**Specification change of the scale range of AC ammeters and voltmeters**

We would like to inform that the omitted range of the scale near zero of the moving-iron meters (AC ammeters and voltmeters) will be changed as follows.

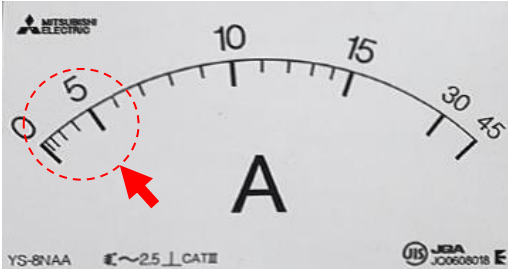
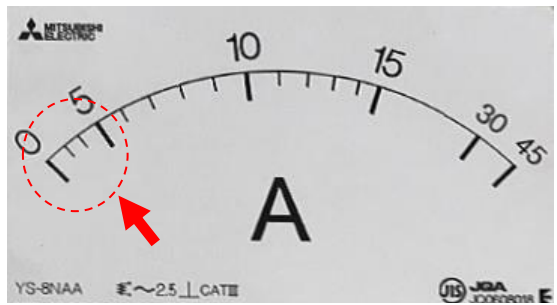
The moving-iron meters have different specification for the scale near zero. In order to avoid the difference between the specifications of each meter, the specification will be changed to the standard scale that is written in the Mitsubishi Mechanical indicators catalogue.

|               | The scale near zero is displayed.  | The scale near zero is omitted.  |
|---------------|--|--|
| Before change |  <p>The scale within the omitted range in the catalogue is displayed.</p> |  <p>The scale line is omitted from 0 to 3 A depending on how to shrink the scale interval.</p> |

|               | The scale near zero is displayed.  | The scale near zero is omitted.  |
|---------------|--|--|
| After change  |  <p>The scale near zero is omitted.</p>                                  |  |
